March 31, 2016

ISSUED FOR USE  
FILE: ENG.WARC03039-01.004  
Via Email: erik.pit@gov.yk.ca

**Subject:** Geotechnical Monitoring Program Review  
Abandoned Clinton Creek Asbestos Mine Site, Yukon

Figure 1 Proposed Monitoring Locations Site Plan

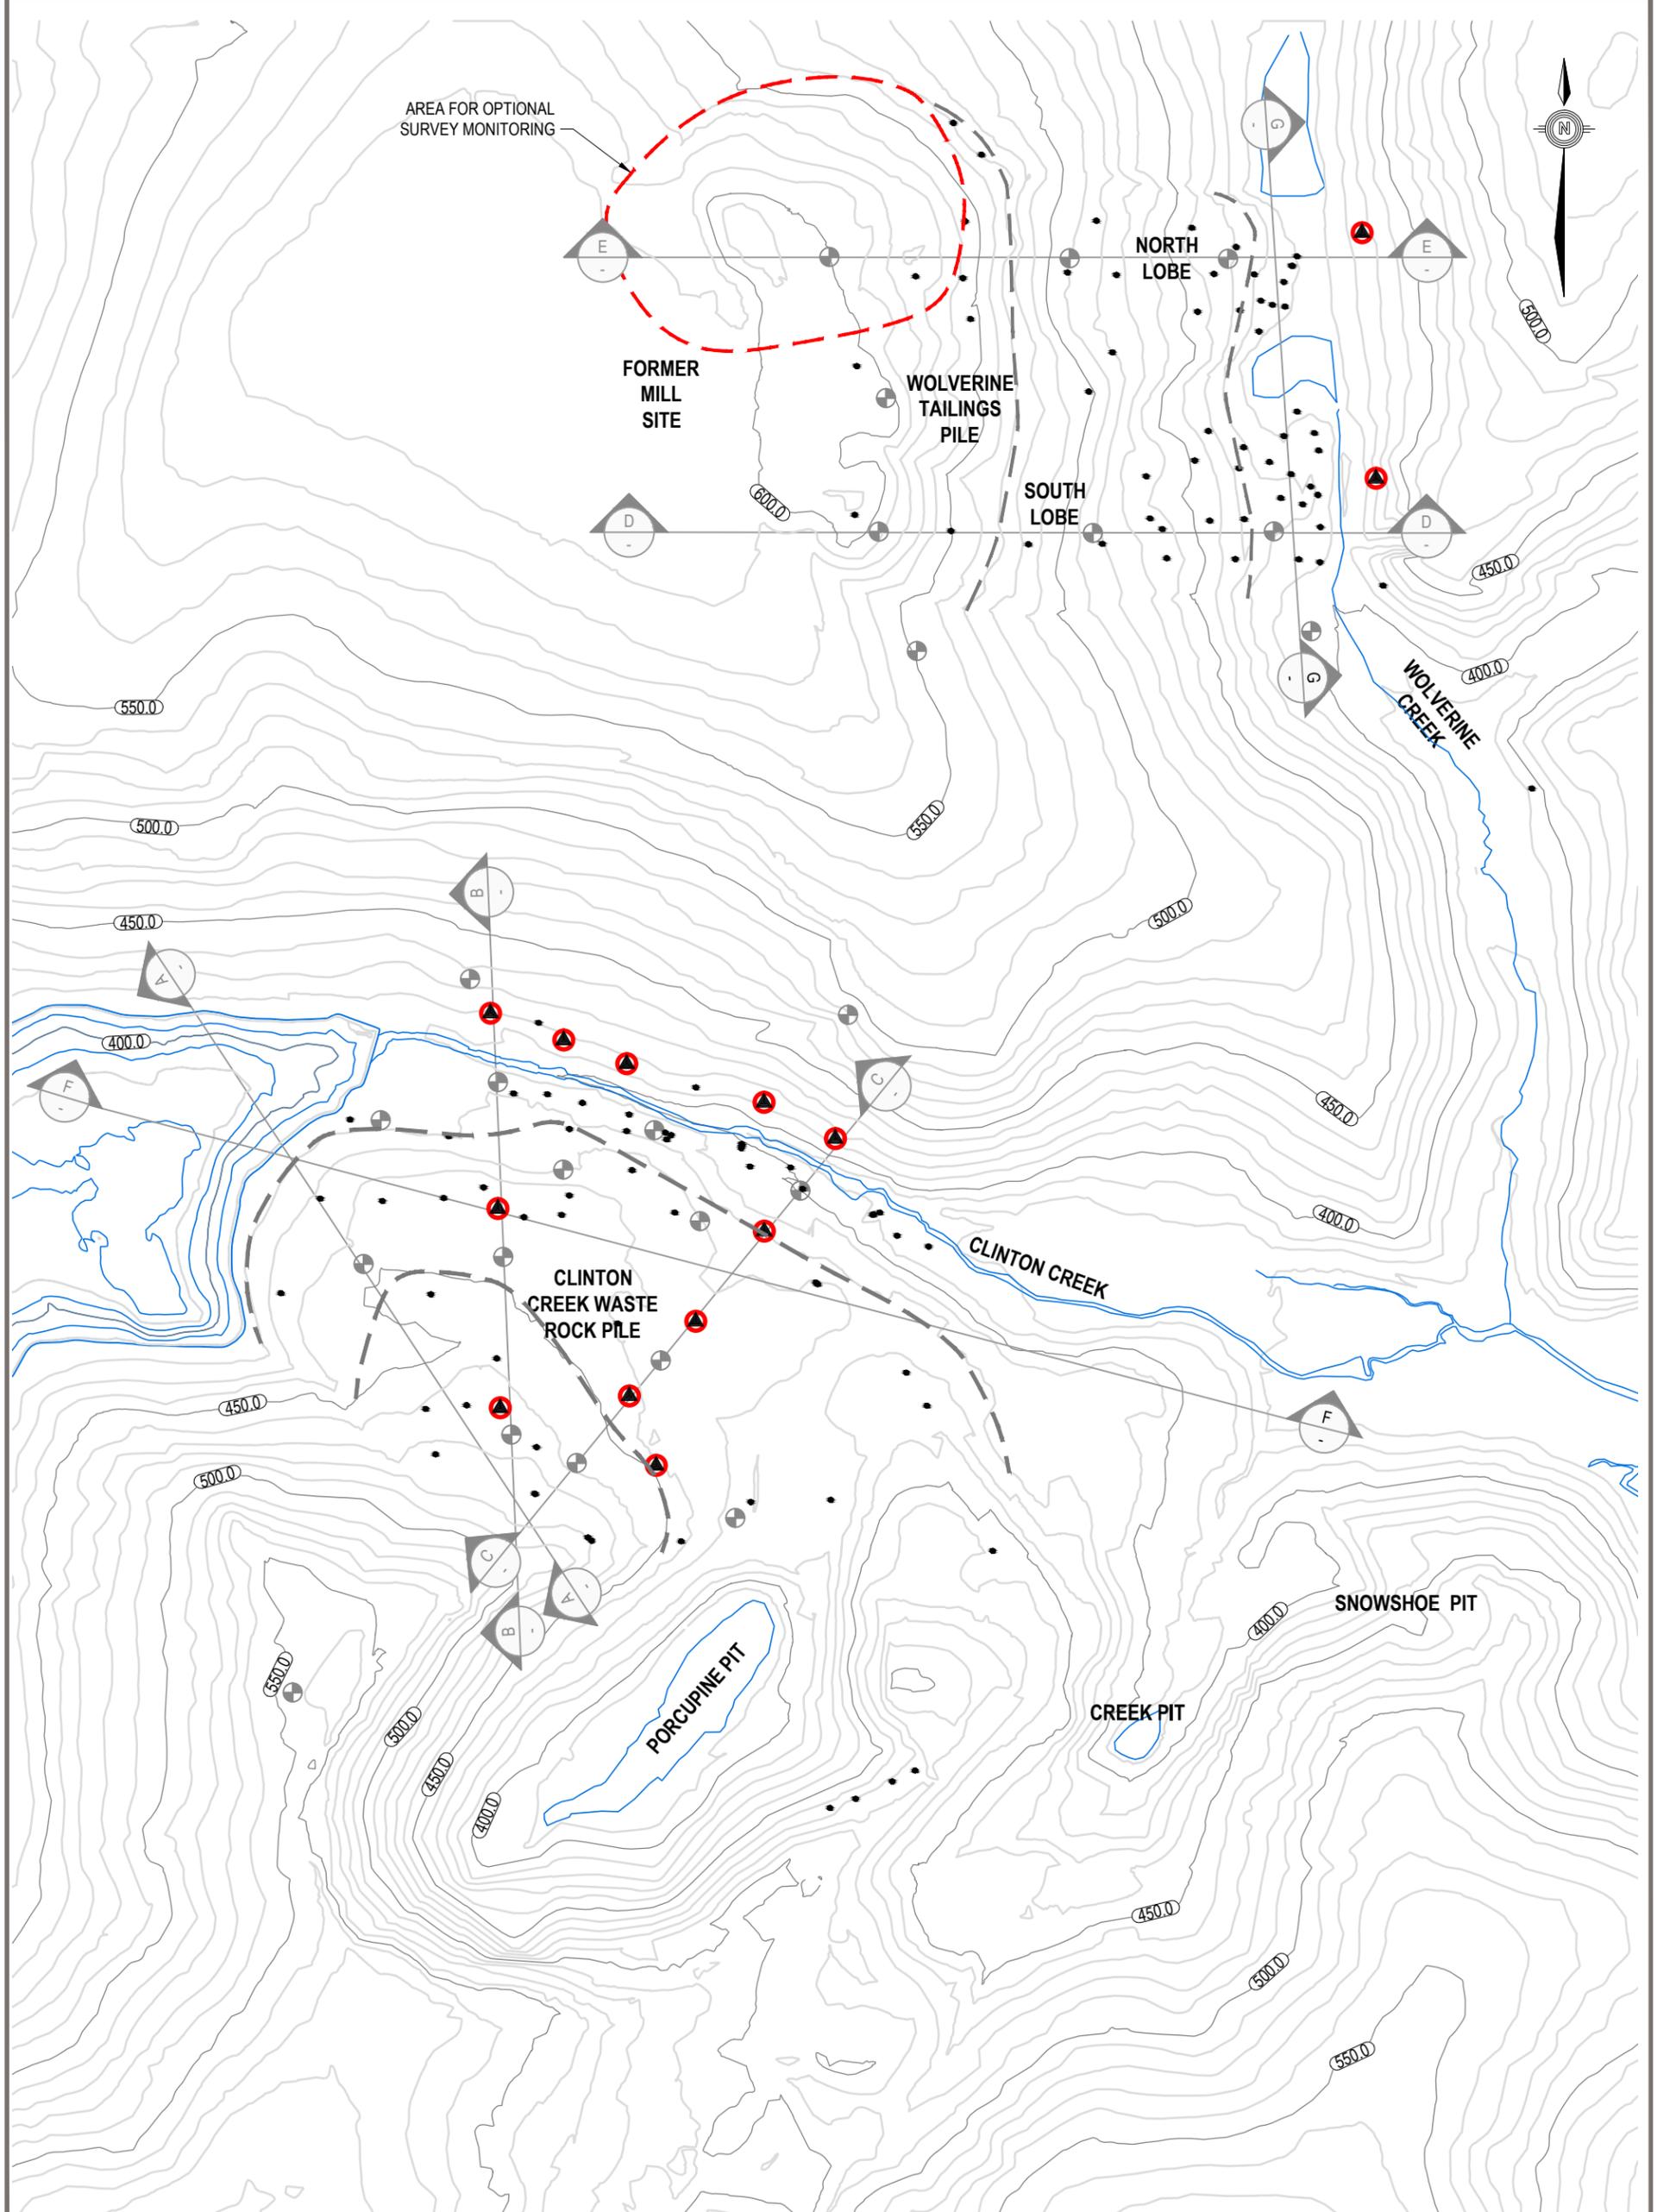
- Additional monitoring points are recommended as follows:
  - The area near Section C-C’ has very few monitoring points and as such forms an information gap – these monitoring points should be installed to establish movement patterns in the area, as well as contribute to evaluating the movement along Section F-F’.

- The toe of the Clinton Creek north valley slope was excavated below original grade as part of the creek diversion works that took place in the 1970s. The impacts on stability from cutting into the side slopes and unloading at the toe are currently unknown. Similarly, some monitoring points should be located on the east side of the Wolverine Creek valley slope, to provide information showing movement (or lack there of) along the east valley slope. Survey of the proposed monitoring points along the north valley and east valley slopes as shown on Figure 1 would allow for an evaluation of any movements detected, and any potential effect they may have on design or construction of remedial options.

- A few additional monitoring points along Section B-B' would provide supplementary data to those already in the area, which could be useful in assessing cross-valley movement, as well as movement along Section F-F'. There are some existing monitoring points in this area, however the proposed monitoring points are located nearer Section B-B', and could be used to better establish cross-valley movement trends along the primary section which was used for the stability analyses. The location of all proposed monitoring points are shown on Figure 1.

- Review of aerial photos reveals the northwest area of the Wolverine Tailngs Pile is actively moving. Although this area appears to be moving in a north-northwesterly direction (likely following natural underlying topography), it is presumably inconsequential to the condition of Wolverine Creek. If there are concerns with the movement in this area from a site management perspective, additional monitoring points could be installed to quantify the movement in this area. The area of discussion has been highlighted on Figure 1.
